Review of “Harmonization of global surface ocean pCO₂ mapped products and their flux calculations; an improved estimate of the ocean carbon sink” by Andrea Fassbender

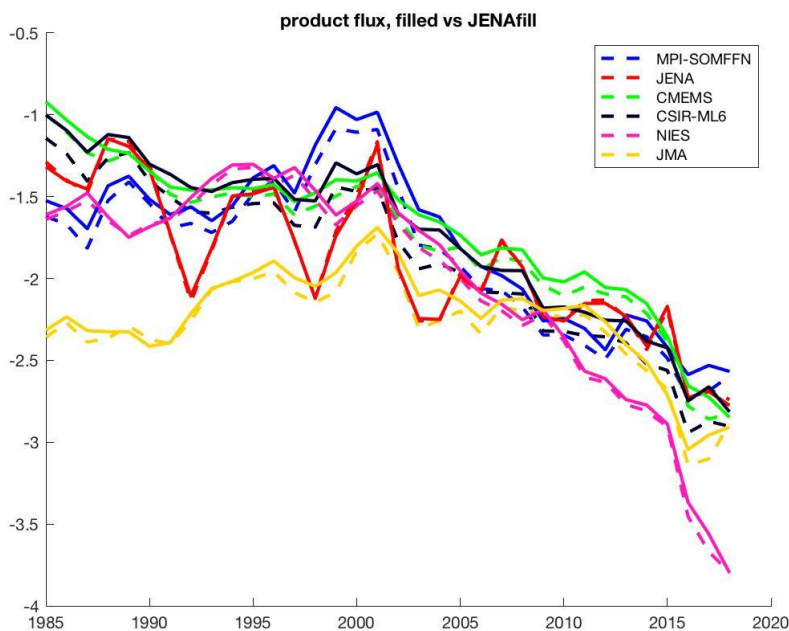
R3: My primary concern is with the pCO₂ scaling approach. It is not clear why the MPI-ULB-SOMFFN climatology was used for gap filling rather than the time evolving JENA-MLS data product. As noted by Reviewer 2, the authors could test their scaling method by using JENA-MLS as the reference data product to see if they achieve similar results.

Response: Thank you for this question. We will respond, as we did with Reviewer 2, that we are aware of at least 4 of the products working towards the goal of full spatial coverage. But until those are released and available we have to work with what we have.

We thank the reviewer for their suggestion of using the Jena-MLS product as an independent estimate of the missing regions. While this does seem like a plausible option from the full-coverage map shown, the Jena-MLS product is stated to be an “open-ocean” product. The creator of the Jena-MLS product (Christian Rodenbeck) specifically cautioned us against using the product as a coastal estimate, specifically stating that CarboScope (aka Jena-MLS product) is an open-ocean product. Additionally, the Jena-MLS product is released in its native resolution as a 4x5 degree map and we have downscaled it to 1x1 degree for this ensemble work.

Therefore, it is not produced in a sufficiently fine-scale resolution to capture coastal and continental shelf processes. The MPI-ULB-SOMFFN climatology is produced at 0.25 degree spatial scale at the coastal margins (up to 400km off land) and therefore provides an improved representation of these regions.

For completeness, we did calculate the resulting flux with the Jena-MLS product pCO_2 used to fill in missing gridcells in the remaining products and present the resulting global mean CO_2 flux timeseries here (dashed lines) along with the flux with filling by the SeaFlux package area-filling method employing MPI-UMB-SOMFFN (solid lines).

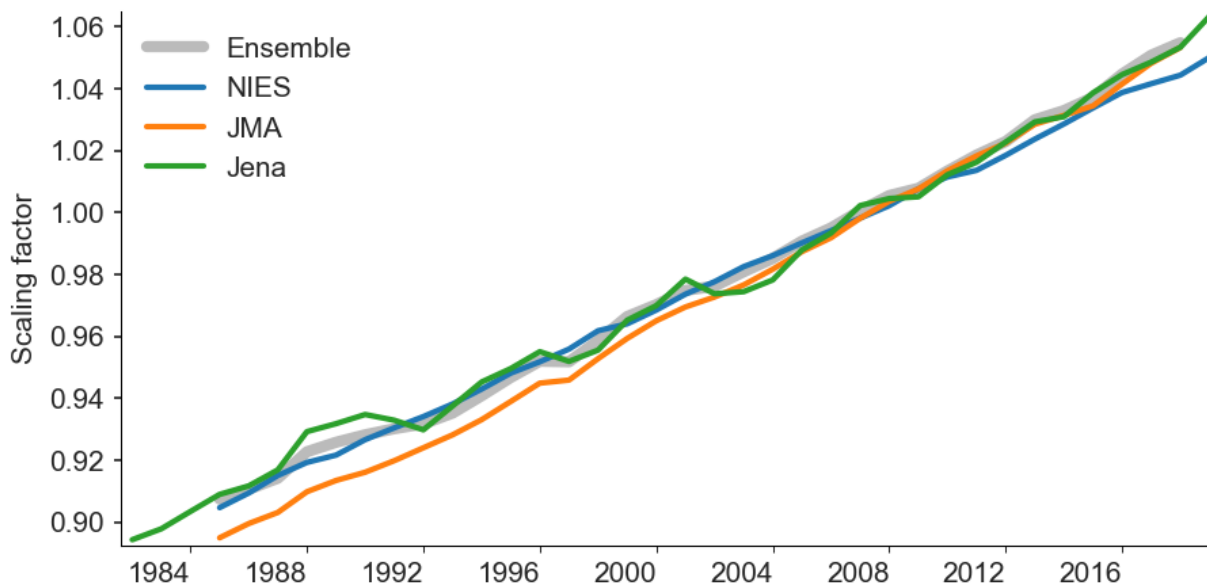
R3: It is also unclear why the authors use an ensemble mean scaling factor when individual scaling factors for each data product may be more appropriate as it would allow more data to be used (i.e., a consistent mask wouldn't be required) to determine the scaling factor for most products. I can understand the desire to maintain consistency in the data extrapolation between products, but it's not clear that this approach makes more sense than creating individual scaling factors for the data extrapolations. More information is needed to explain why this decision was made.

Response: We considered the option of calculating individual scaling factors but opted to present the ensemble approach for it provides strengths with regard to capturing a forced signal common to all products. We acknowledge that a scaling factor for each product would be much more sensitive to interannual variability in the products however we don't see that as a strength when considering long-term global mean averages. We present here a comparison of a scaling factor for various products to that of the ensemble mean.

Scaling factors for the ensemble product (thick grey line). We only show NIES, Jena and JMA methods. The remaining methods are more similar to the ensemble scaling factor than the methods shown in the figure above. The JMA-MLR approach shows the largest difference from the ensemble mean, which is on average 0.6% (max of 1.7%) for pCO₂. When propagated through to fluxes, this equates to an average difference of 0.04 Pg yr⁻¹ when compared with the scaling factor computed with the ensemble. For reference, filling results in a ~0.25 Pg yr⁻¹ larger uptake by the ocean (as shown in the figure on the following page). Thus, even in the worst case scenario, the difference is small.

(a)

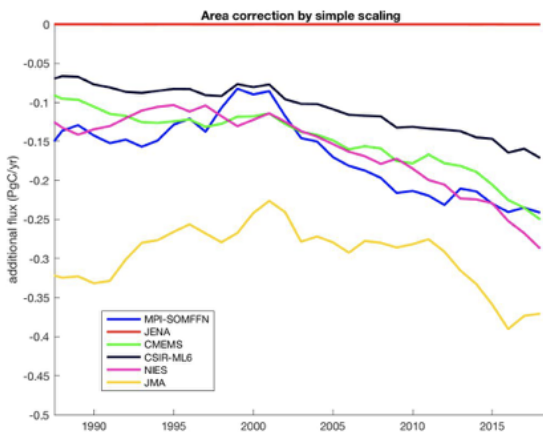
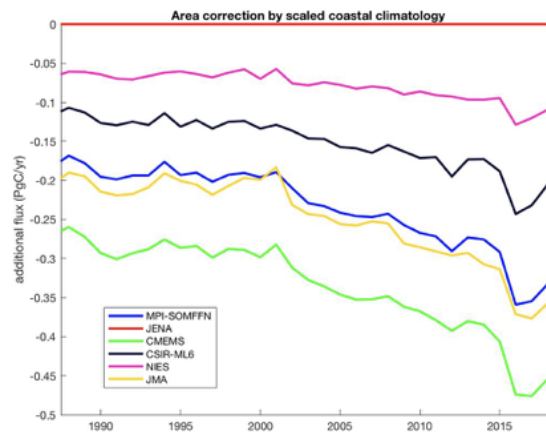
R3: As a sensitivity test, the authors could apply their methodology using JENA-MLS to scale MPI-ULB-SOMFFN (and vice versa) directly AND using an ensemble mean, to see which yields a better result. They could also do this using (1) the common missing data mask as well as (2) each missing data mask from the four other data products to evaluate whether the resulting extrapolation bias is sensitive to the extrapolation area. The authors could also apply the linear-scaling approach used in the Global Carbon Budget (GCP) to MPI-ULBSOMFFN and JENA-MLS (using the missing data masks from the four other products) to quantify the resulting extrapolation biases and determine whether their approach is indeed more accurate than the GCP method. The suggested analyses may help clarify which approach is best for achieving data product comparability.

For the first comment regarding a sensitivity test, we have shown the comparison in resulting flux when using the Jena-MLS product to fill in missing areas of all the other products, however

we remind the reviewer that this is simply a comparison but not the preferred method as Jena-MLS is an open-ocean product and should not be used as a parameterization for coastal regions. However we also question how one would define “a better result” as suggested by the reviewer as the “truth” is of course unknown.

To respond to the idea of applying the linear-scaling approach used in the GCB, one strength of the SeaFlux approach is that it deals directly with the pCO_2 in the various pCO_2 interpolation products rather than adjusting their fluxes after the fact. These products are created to represent (nearly) full coverage pCO_2 . They often will also calculate a flux field and report it as well, but the approach itself is developed and tuned to represent pCO_2 values. So by calculating a global flux and then adjusting it by a missing area factor you are skipping over the point that there are pCO_2 values missing and how that unknown could cascade in the flux calculation itself. Here we show that the additional flux for each product resulting from the area-filling method proposed here in the SeaFlux package is on the same scale and magnitude as the method utilized by the GCB. Below is an annual time series of the additional flux amount calculated by the area-weighted method used in the Global Carbon Budget (a) and a similar plot showing the annual additional flux using the SeaFlux methodology (b).
